Technical Service Bulletin

SUBJECT:		No: TSB-21-33-001	
UPDATES TO FRONT SUSPENSION - SERVICE MANUAL REVISION		DATE: October 2021	
		MODEL: See Below	
CIRCULATE TO:	<input type="checkbox"/> GENERAL MANAGER	<input checked="" type="checkbox"/> PARTS MANAGER	<input checked="" type="checkbox"/> TECHNICIAN
<input checked="" type="checkbox"/> SERVICE ADVISOR	<input checked="" type="checkbox"/> SERVICE MANAGER	<input checked="" type="checkbox"/> WARRANTY PROCESSOR	<input type="checkbox"/> SALES MANAGER

This TSB provides updated content for the Front Suspension section of the affected Service Manual.

- 2020 Eclipse Cross Service Manual, Group 33 - Front Suspension -> Lower Arm Removal and Installation- Attached sheet 7

ACH05320 AB

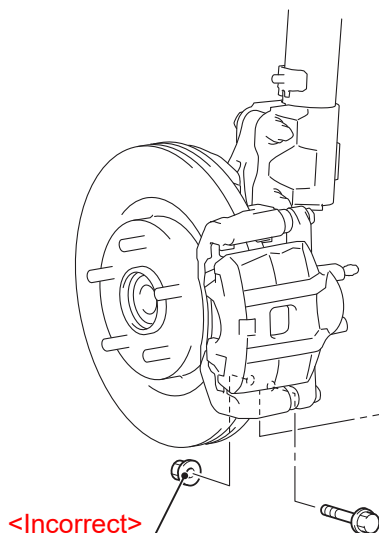
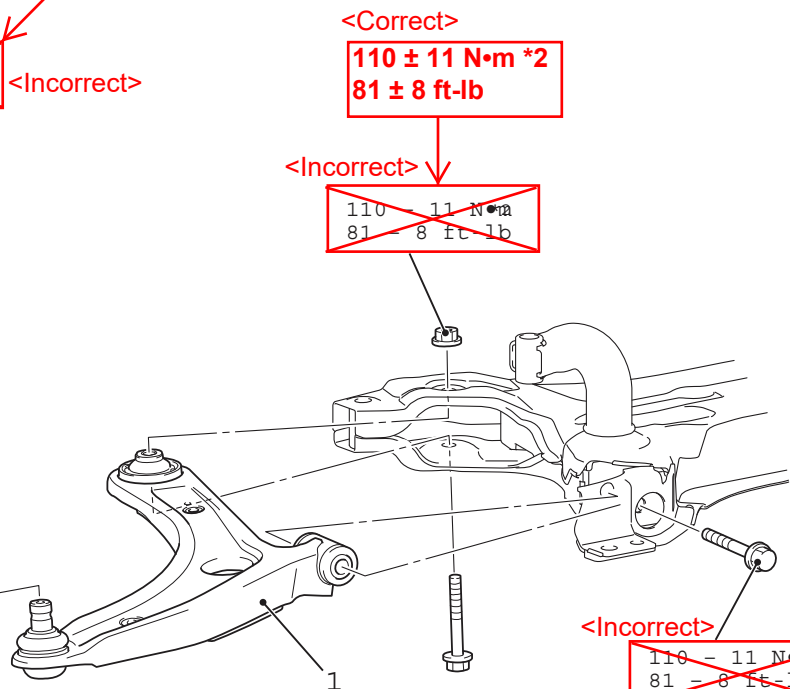
- The parts indicated by *1 indicates parts which should be temporarily tightened, and then fully tightened with the vehicle standing on the ground at curb weight.
- The parts indicated by *2 are the bolts/nuts with friction coefficient stabilizer. Prior to reinstallation, ensure there is no damage, clean dust and soiling from the bearing and thread surfaces, and tighten them to the specified torque.

<Incorrect>
~~71 ± 10 N·m
52 ± 7 ft-lb~~

<Incorrect>
~~110 ± 11 N·m
81 ± 8 ft-lb~~

<Incorrect>
~~110 ± 11 N·m, 2
81 ± 8 ft-lb~~

<Correct>
Multipurpose grease
SAE J310, NLGI No.2 or equivalent

<Correct>
71 ± 10 N·m
52 ± 7 ft-lb

<Correct>
110 ± 11 N·m *2
81 ± 8 ft-lb

<Correct>
110 ± 11 N·m *1,2
81 ± 8 ft-lb
